Regulations Nos. 13 and 13-H (Braking) – Clarifications

Proposal for amendments to Regulation No. 13 (Heavy vehicle braking) and 13-H (Brakes of M₁ and N₁ vehicles)

Submitted by the experts from Germany*

Proposal for Supplement 11 to the 11 series of amendments to Regulation No. 13

Annex 14 - Appendix

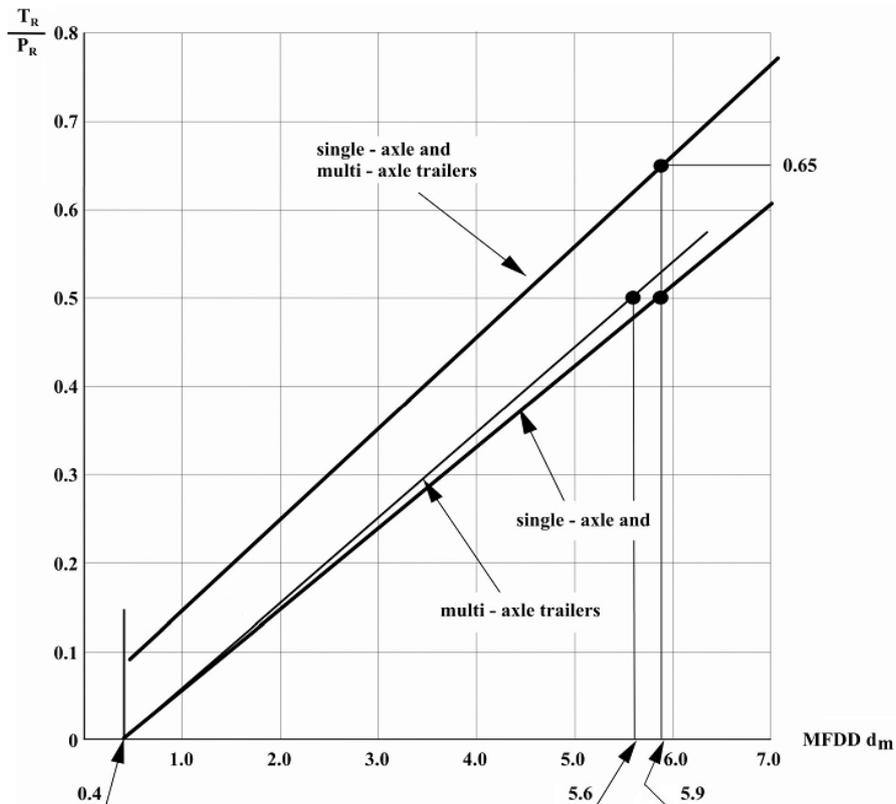
In the diagram the terms "centre-axle trailer" and "semi-trailer" shall be used in stead of "single-axle trailer". The term "full trailer" shall be used in stead of "multi-axle trailer".

15. It is not clear which requirements should be applied to semi-trailers. The current requirements apply to single axle trailers and multi axle trailers. That could be interpreted as centre axle trailers and full trailers.

16. The prescriptions regarding the axle spread are not relevant if the terms "centre-axle trailer", "semitrailer" and "full trailer" are used.

17. Therefore the diagram in the appendix to Annex 14 also has to be amended accordingly.
